MONTGOMERY COUNTY PLANNING DEPARTMENT
THE MARYLAND-NATIONAL CAPITAL PARK AND PLANNING COMMISSION

Staff Report: Preliminary Plan 120090100: Shady Grove Metro – P146
Site Plan 820090070: Shady Grove Metro – P146

MCPB HEARING DATE: October 22, 2009

Revised Layout

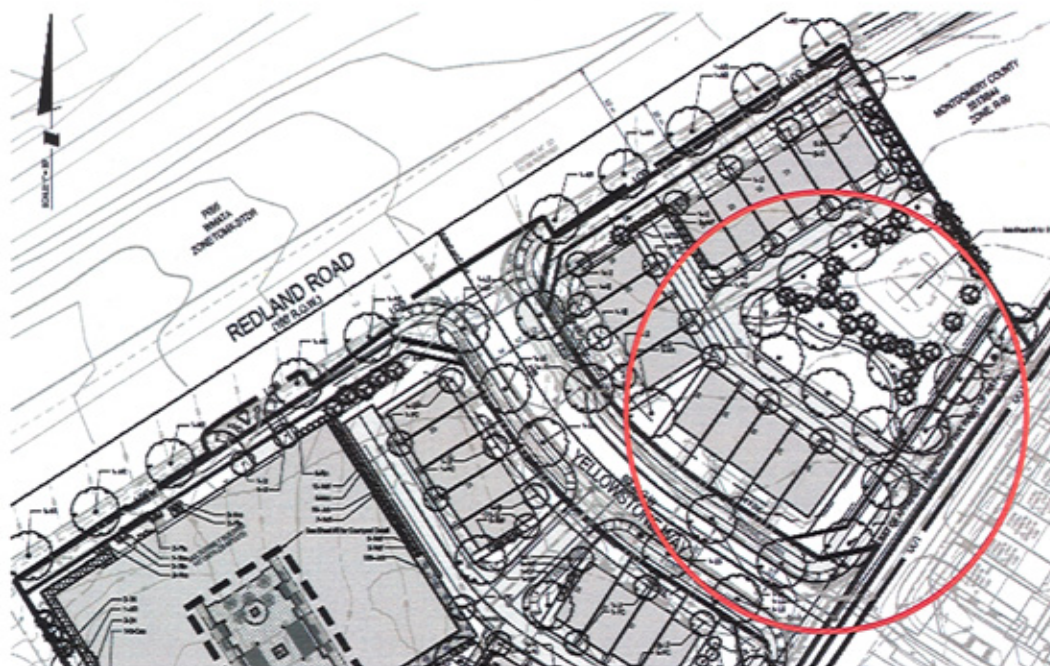
application submitted for preliminary and site plan approvals. The substantive changes include the reorientation of townhomes along Yellowstone Way, the vehicular access to the eastern section of the development, and the relocation of the stormwater pond; these were done at the request of Planning Department Staff.

1. The original submittal must be revised as shown on the "Revised Layout" plan shown on page 6 of this staff report. This includes reducing the size and relocating the stormwater pond to the eastern edge of the site; relocating the internal stick of townhouses to front on Yellowstone Way; relocating the vehicular access to the townhouses on the eastern portion of the site from Yellowstone Way to Chieftain Avenue; and any necessary internal site improvement modifications.
2. The revised layout must be approved by DPS prior to the certification of the site plan. If the revised layout cannot be approved, this site plan must be amended.
